Review of Instrument Unit Emergency Detection System at IBM/Huntsville on September 1 Case 330

October 12, 1966 DATE:

T. F. Loeffler FROM:

#### MEMORANDUM FOR FILE

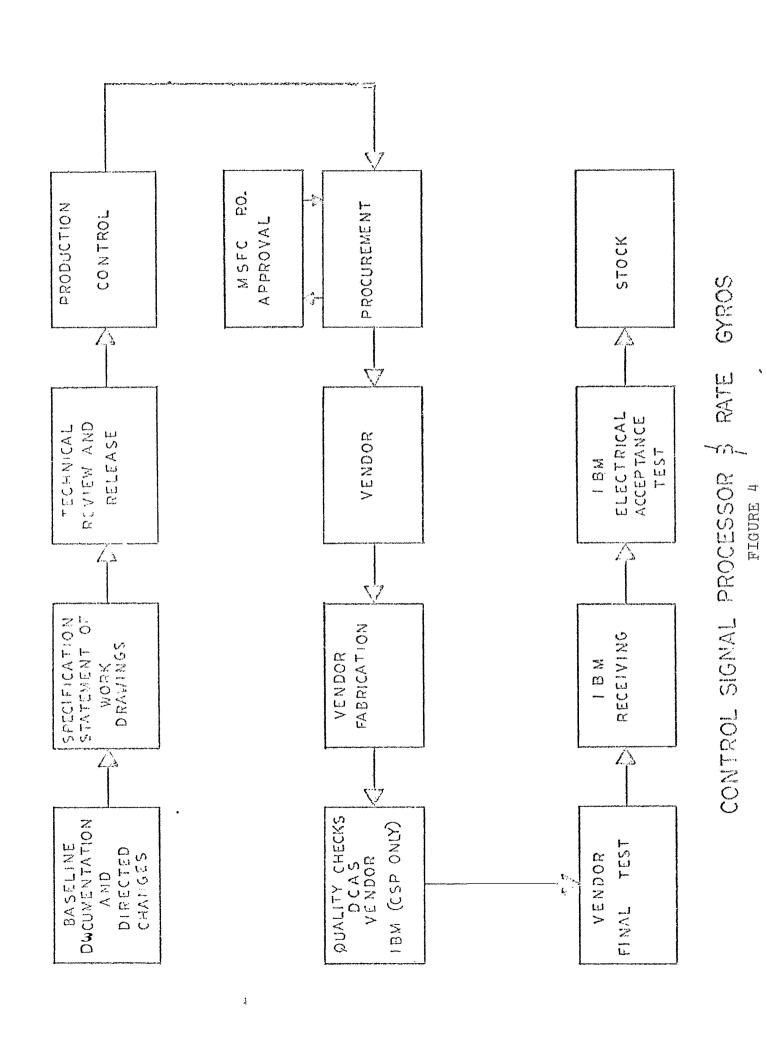
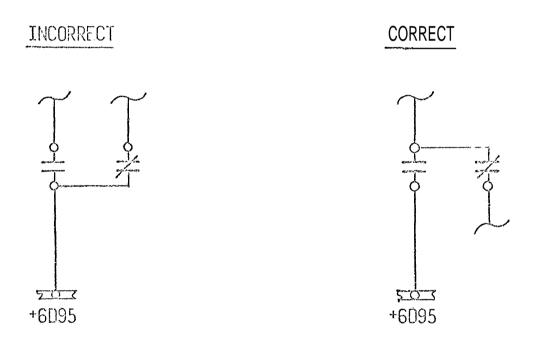
- 3. IU Electrical System: The functional block diagram of Figure 5, Appendix B, was shown and explained.
- 4. Voting relay and associated circuit design philosophy: The 9 items shown on Figure 6, Appendix B, were discussed.
- 5. IU EDS component design criteria were given as:

A question was raised regarding the type and extent of insulation of the 6D95 Auto Abort Bus bar; it was agreed that an insulating coating would be applied in all exposed places to prevent accidental contacts to these bus bars.

# CIRCUIT DIAGRAM REDUNDANT POWER TO EDS UCN-4853

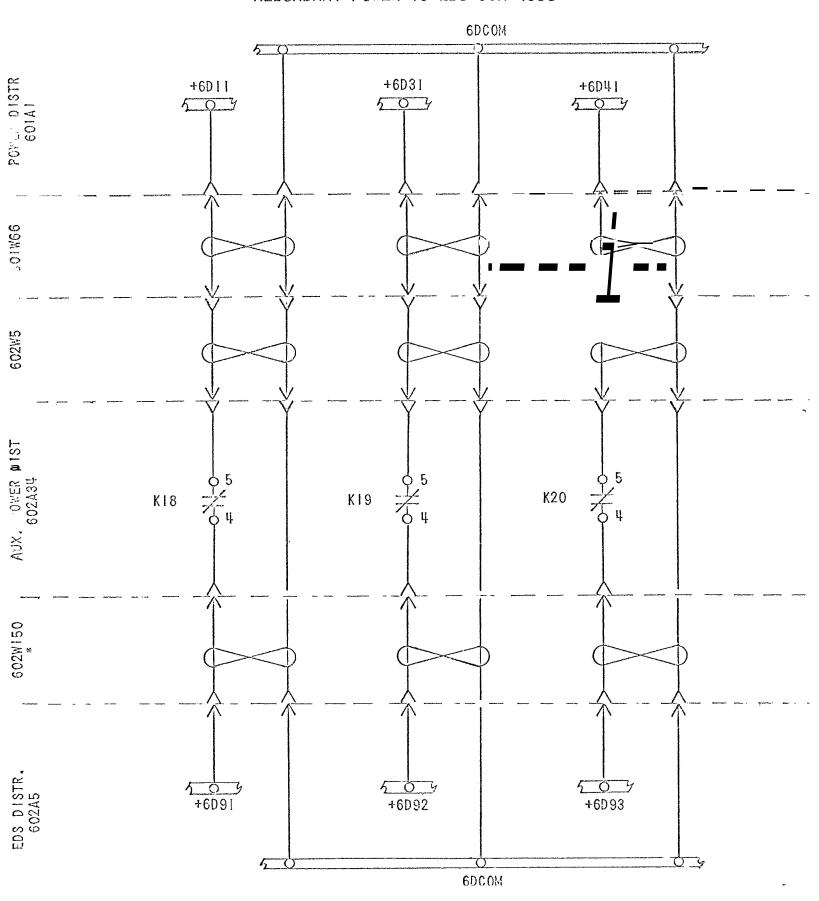
- 6. IU 201 Problems and Their Solutions: In the Control Signal processor excessive vehicle vibration (during SA-201) caused noisy signal in the gyro circuits. This problem was solved by inserting a low pass filter into the circuit. A harmonic distortion problem in the rate gyro circuits was solved by changing of scale factors.
- 7. Single Point Failure Problem Areas; There is only a single cable (and connector) each leading from the TU Batteries to the Power Distributor, from there to the Auxiliary Power Distributor, and then to the EDS Distributor, as shown in Figures 9A & B. Proposed new cable branches in parallel with the present ones would provide the desired redundancy.

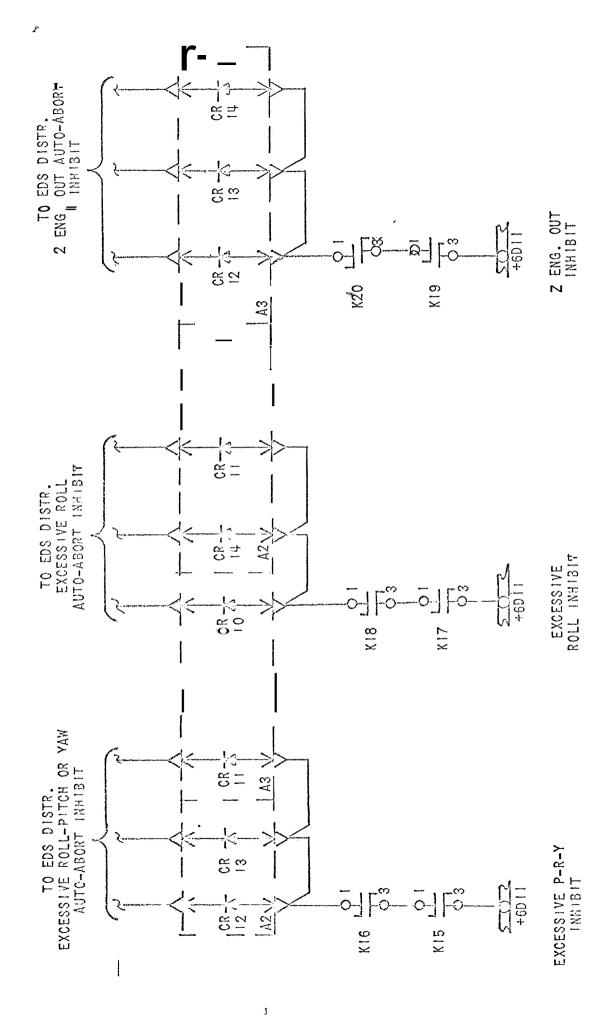
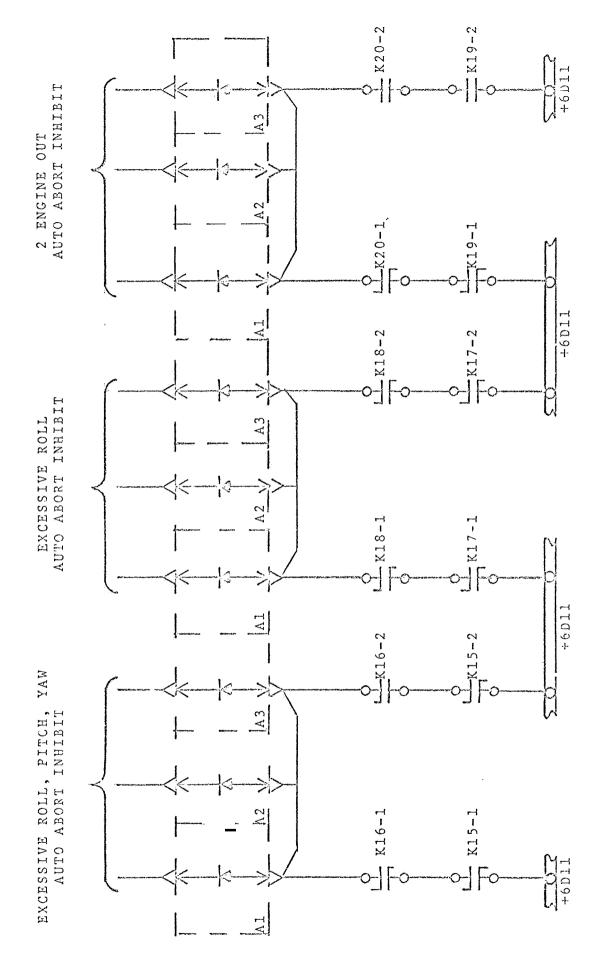
In the IU Control Distributor, there is a single path each, in the two "excessive rate inhibit" and the "two-engine out inhibit" circuits, as shown in Figure 10A. The proposed redundancy shown in Figure 10B would provide the desired dual paths.
